Product Change Notification

Product Group: SIL/Mon Sep 28, 2020/PCN-SIL-0362020-2020-REV-0

Commercial Power MOSFET Manufacturing Capacity Expansion

TO-247AC Outline

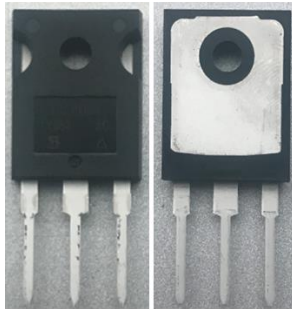
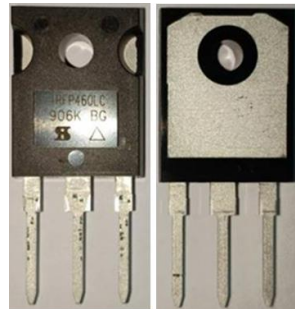
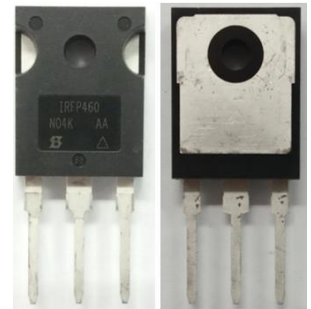
EXPECTED INFLUENCE ON QUALITY/RELIABILITY/PERFORMANCE: There will be no affect on the quality, reliability, or performance. There will be no changes in minimum and maximum values on the data sheets. The finished good appearance and outline dimension variance are shown in annex.

Outline Drawing Comparison

TO247AC	JEDEC		XI'AN		GEM HF		ASE WH		Change (GEM vs. ASE)
Symbol	Min	Max	Min	Max	Min	Max	Min	Max	
A	4.65	5.31	4.65	5.31	4.83	5.21	4.65	5.31	-0.18 / +0.10
A1	2.21	2.59	2.21	2.59	2.29	2.55	2.21	2.59	-0.08 / +0.04
A2	1.50	2.49	1.17	1.37	1.50	2.49	1.17	1.37	-0.33 / -1.12
b	0.99	1.40	0.99	1.40	1.12	1.33	0.99	1.40	-0.13 / +0.07
b1	0.99	1.35	0.99	1.35	1.12	1.28	0.99	1.35	-0.13 / +0.07
b2	1.65	2.39	1.65	2.39	1.91	2.39	1.65	2.39	-0.26 / +0.00
b3	1.65	2.34	1.65	2.34	1.91	2.34	1.65	2.34	-0.26 / +0.00
b4	2.59	3.43	2.59	3.43	2.87	3.22	2.59	3.43	-0.28 / +0.21
b5	2.59	3.38	2.59	3.38	2.87	3.18	2.59	3.38	-0.28 / +0.20
c	0.38	0.89	0.38	0.89	0.55	0.69	0.38	0.89	-0.17 / +0.20
c1	0.38	0.84	0.38	0.84	0.55	0.65	0.38	0.84	-0.17 / +0.19
D	19.71	20.70	19.71	20.70	20.40	20.70	19.71	20.70	-0.69 / +0.00
D1	13.08	—	13.08	—	16.25	16.85	13.08	—	-3.17 / none
D2	0.51	1.35	0.51	1.35	0.56	0.76	0.51	1.35	-0.05 / +0.59
E	15.29	15.88	15.29	15.87	15.50	15.87	15.29	15.87	-0.21 / +0.00

E1	13.46	—	13.46	—	13.46	14.16	13.46	—	+0.00 / none
e	5.46		5.46 BSC		5.46 BSC		5.46 BSC		None
Ø K	0.25		0.254		—		0.254		None
L	14.20	16.10	14.20	16.10	14.90	15.40	14.20	16.10	-0.70 / +0.70
L1	3.71	4.29	3.71	4.29	3.96	4.16	3.71	4.29	-0.25 / +0.13
N	—		7.62 BSC		—		7.62 BSC		None
Ø P	3.56	3.66	3.56	3.66	3.56	3.65	3.56	3.66	+0.00 / +0.01
Ø P1	—	7.39	—	7.39	—	7.19	—	7.39	none / +0.20
Q	5.69	5.82	5.31	5.69	5.31	5.69	5.31	5.69	None
R	4.52	5.49	4.52	5.49	4.52	5.49	4.52	5.49	None
S	5.51		5.51 BSC		5.54	5.74	5.51 BSC		None
